<https://www.emnrd.nm.gov/ocd/contact-us/>State of New Mexico
Energy, Minerals and Natural ResourcesForm C-103
Revised July 18, 2013OIL CONSERVATION DIVISION
1220 South St. Francis Dr.
Santa Fe, NM 87505

SUNDRY NOTICES AND REPORTS ON WELLS (DO NOT USE THIS FORM FOR PROPOSALS TO DRILL OR TO DEEPEN OR PLUG BACK TO A DIFFERENT RESERVOIR. USE "APPLICATION FOR PERMIT" (FORM C-101) FOR SUCH PROPOSALS.) 1. Type of Well: Oil Well ☐ ☒ Gas Well ☐ Other		7. Lease Name or Unit Agreement Name GACH 31 STATE
2. Name of Operator Maverick Permian LLC		8. Well Number 001
3. Address of Operator 1000 Main Street Ste 2900 Houston, TX 77002		9. OGRID Number 331199
4. Well Location Unit Letter O : 990 feet from the South line and 1650 feet from the east line Section 31 17S Township 34E Range NMPM County		10. Pool name or Wildcat [86840] VACUUM; MORROW (GAS
11. Elevation (Show whether DR, RKB, RT, GR, etc.) 4083

Gach 31 State #1 P&A Procedure

Action 369630

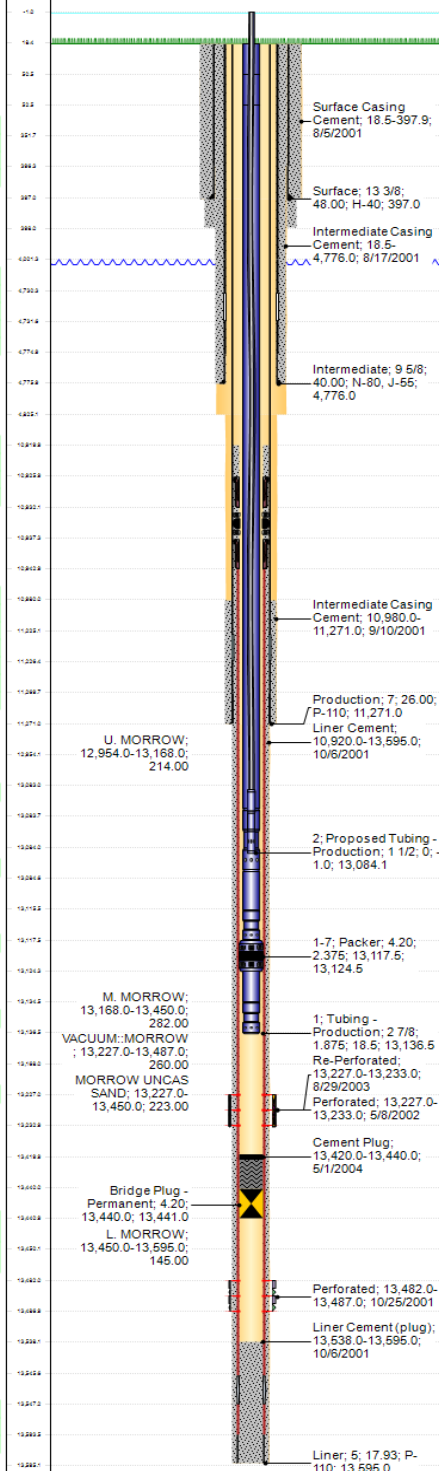
Note changes to procedure

4" diameter 4' tall Above Ground Marker

**Perf @ 425'. Attempt to sqz (do not exceed 500 psi) Class C
cement f/ 425' and ciruclate to surface then top fill. Isolates
Surface casing shoe.**
